To modify the wiring of the connector for the TPMxxx pressure modules to use the module with the adapter interface box, a wire must be removed from one pin of the connector to another.

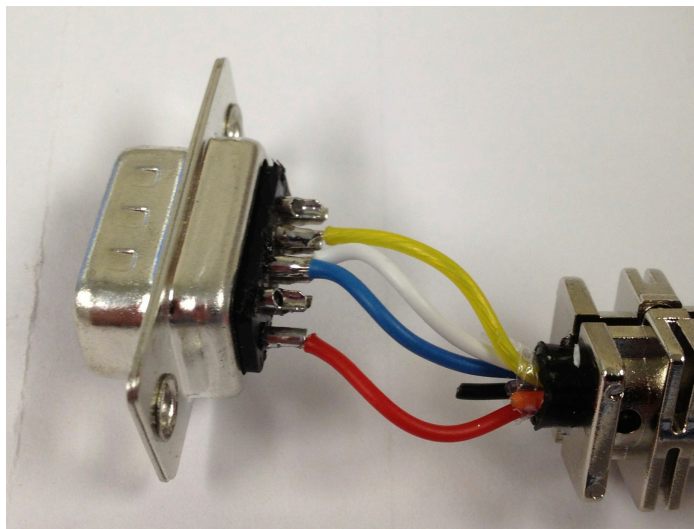
The standard connection is that both the Blue and White leads are connected to the same PIN (Pin 2)

The wiring should be modified to the following :

Red Wire (+ve Supply) – Pin 1  
Yellow Wire (+ve Output) – Pin 8  
Blue Wire (-ve Output) – Pin 7  
White Wire (-ve Supply) – Pin 2

Please note that the pressure module should then always be used with the adapter interface box plugged in between the pressure transducer and the calibrator
